RECONSTRUCT RUNWAY 4-22

TUSCALOOSA NATIONAL AIRPORT
TUSCALOOSA, ALABAMA

ADDENDUM No. 1

May 05, 2020

| CLIENT: TUSCALOOSA NATIONAL AIRPORT | | PROJECT: RECONSTRUCT RUNWAY 4-22 | | SHEET TITLE: RUNWAY MARKING PLAN - SHEET 1 | |

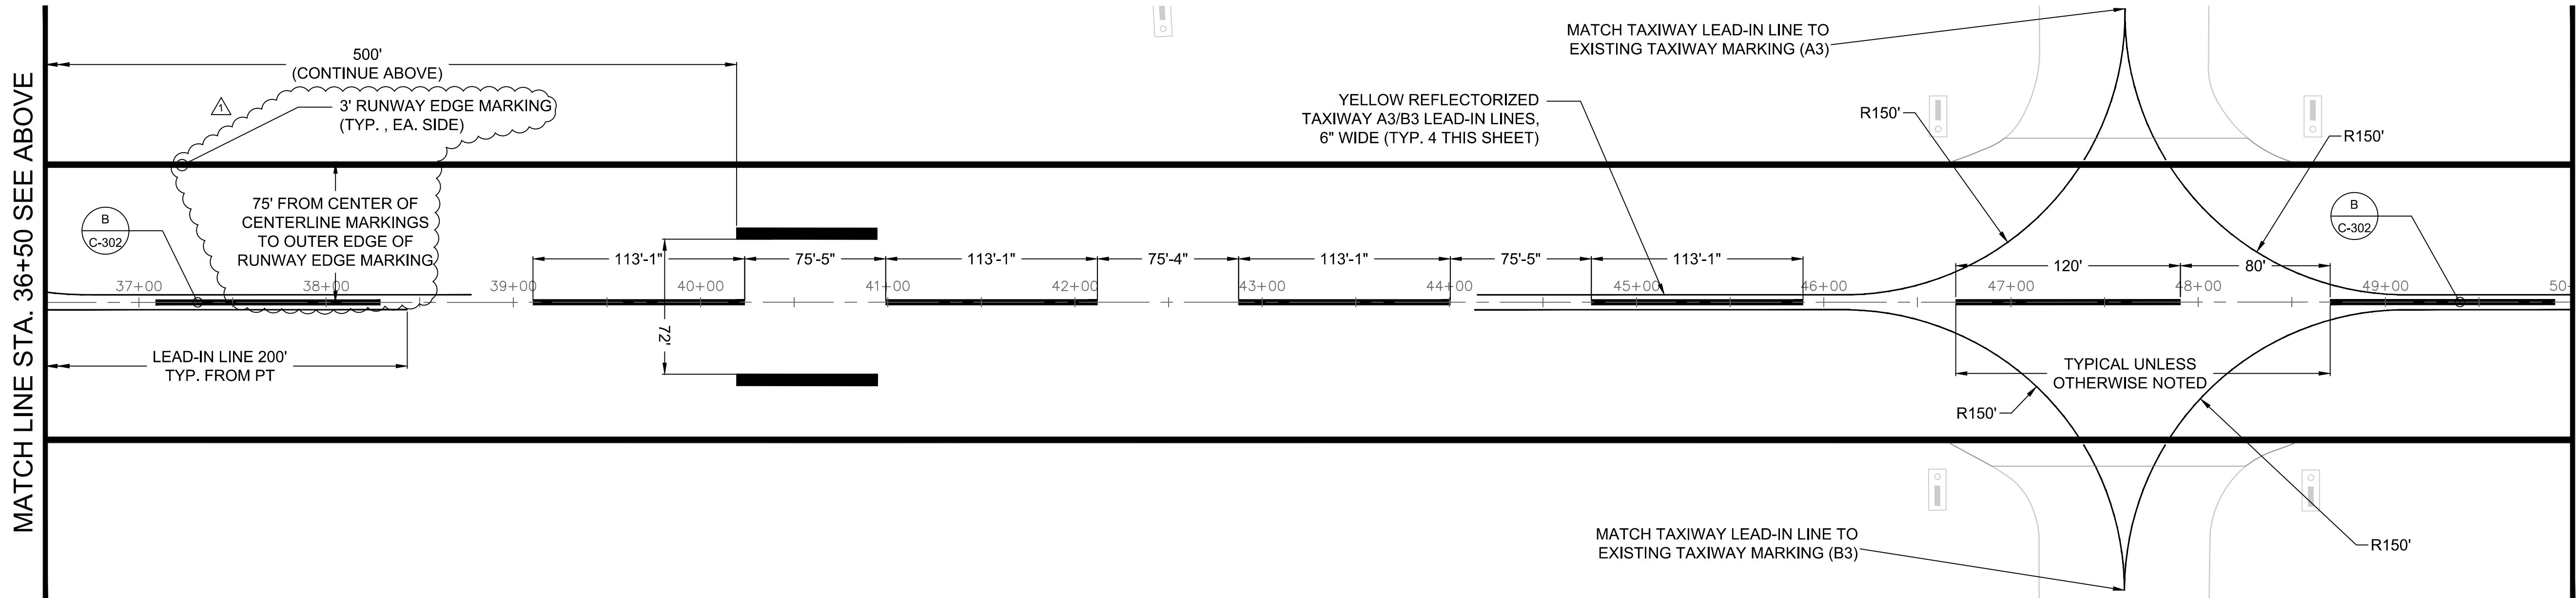
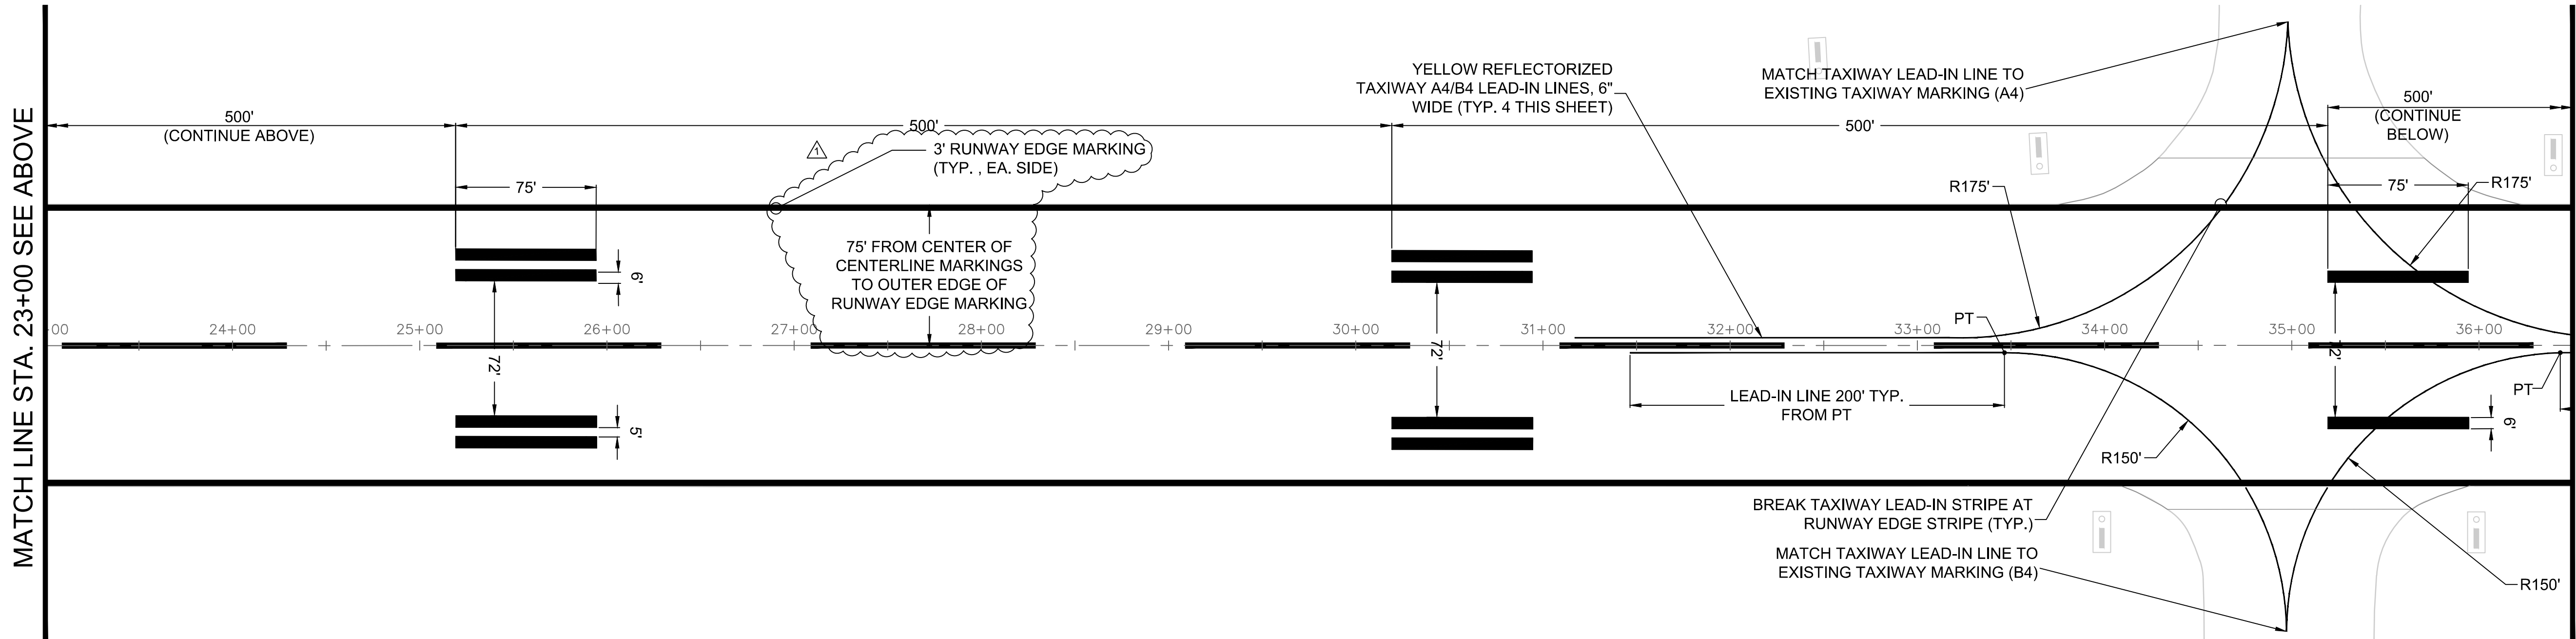
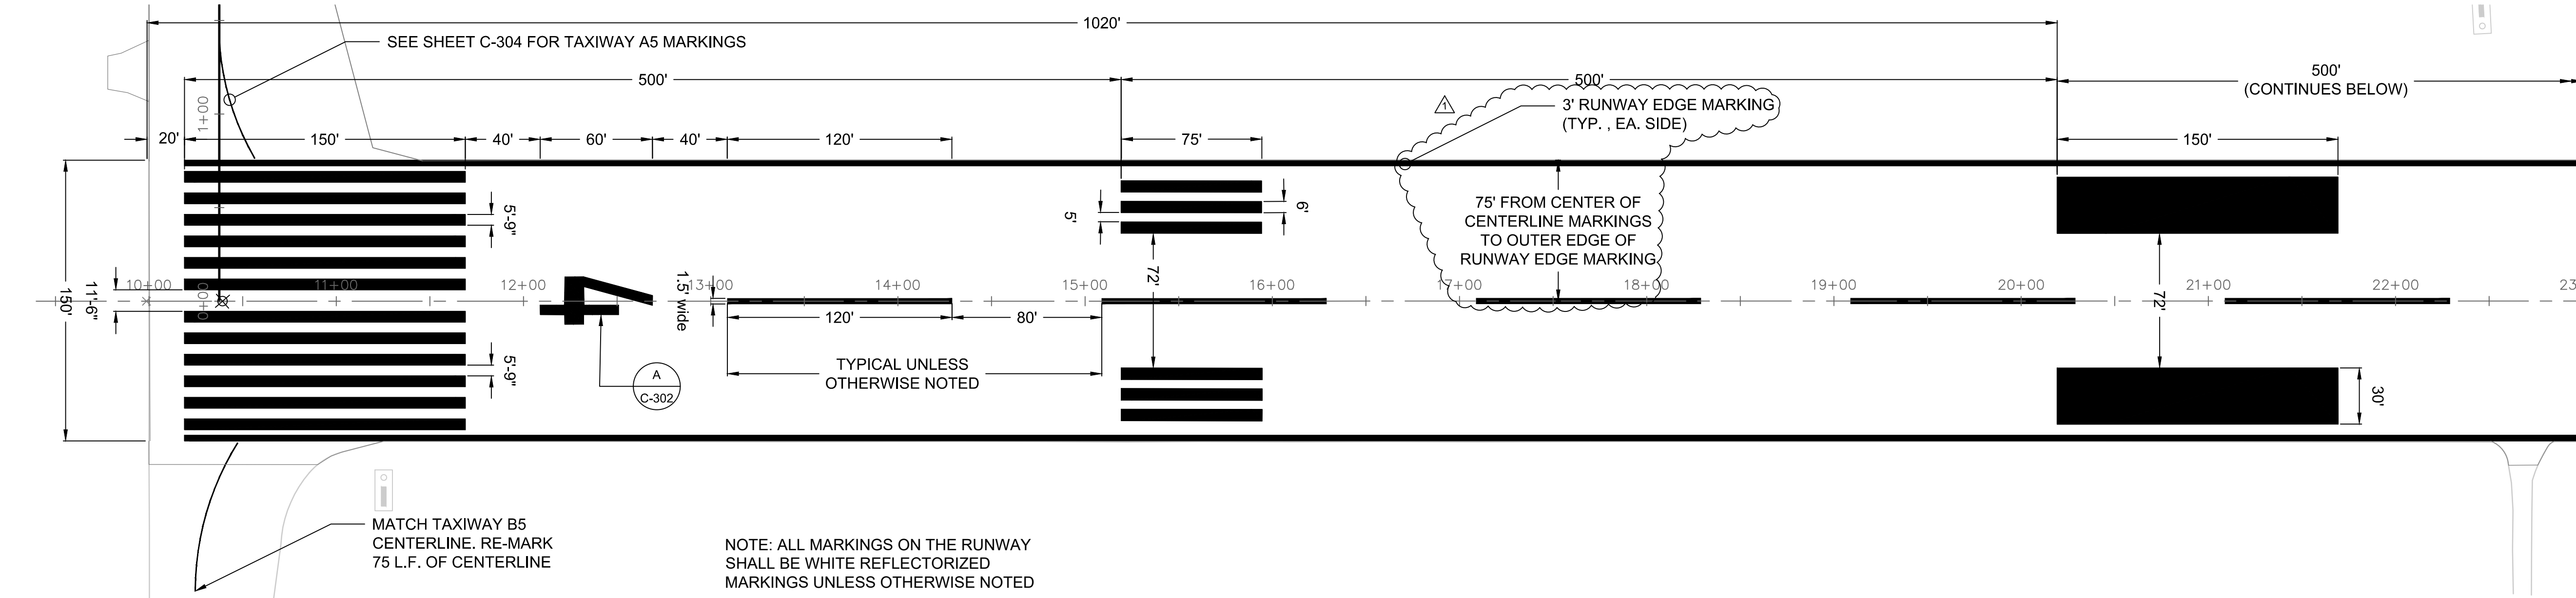
5. Sheet C-301, Runway Marking Plan – Sheet 1, **REPLACE** this sheet with the like-numbered sheet included with this transmittal. The purpose of this change is to indicate the required width of the runway edge marking and the distance from the center of the runway to the outer edge of that marking.

| 1 | | CDD 4/30/2020 | | ADDED EDGE MARKING DIMENSION | |

| <p>SHEET NO.</p> <p>C-302</p> | | | | | | | | | | <p>REVISION</p> | | | | | | | | | | <p>DATE</p> | | | | | | | | | |

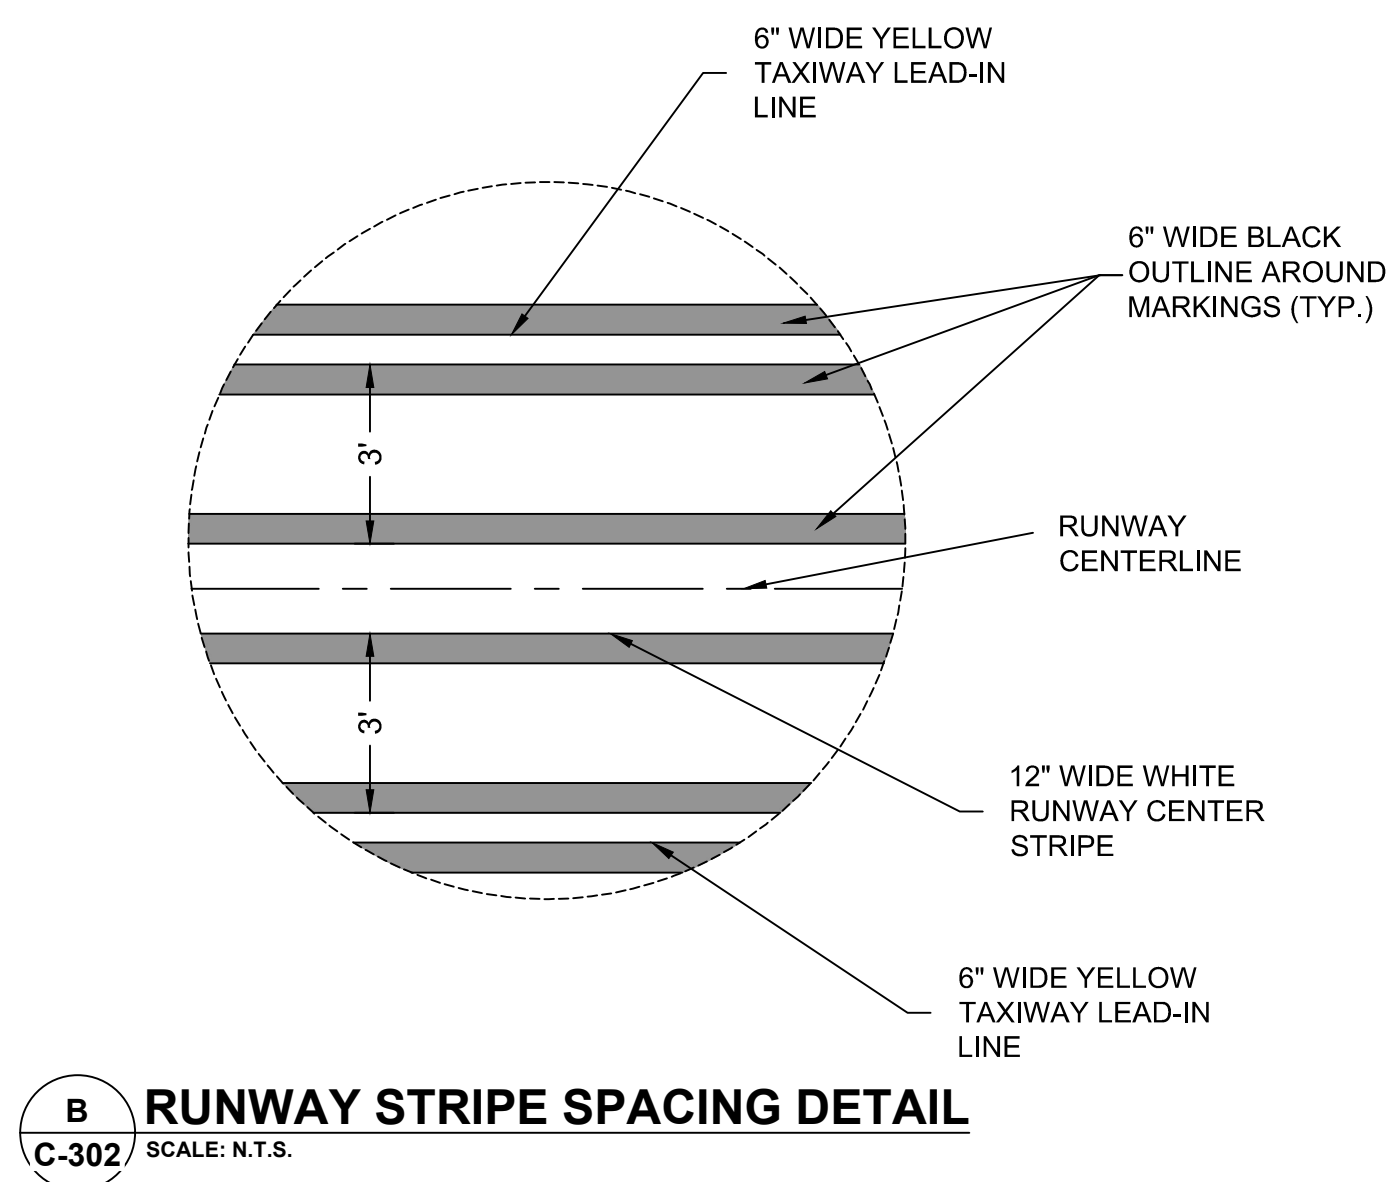
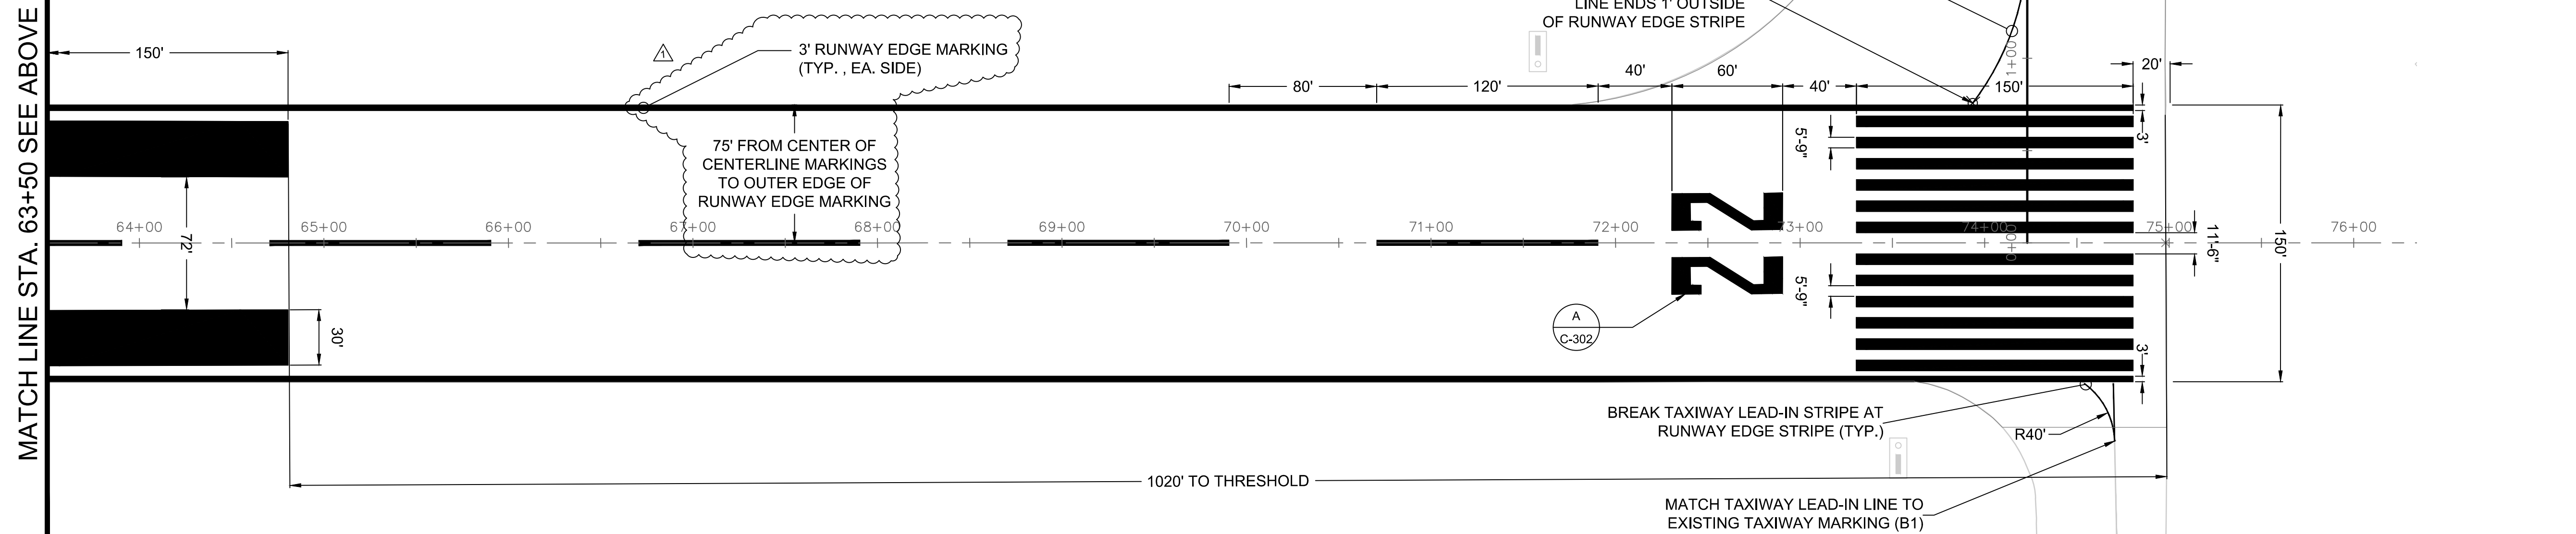
6. Sheet C-302, Runway Marking Plan – Sheet 2, **REPLACE** this sheet with the like-numbered sheet included with this transmittal. The purpose of this change is to indicate the required width of the runway edge marking and the distance from the center of the runway to the outer edge of that marking.
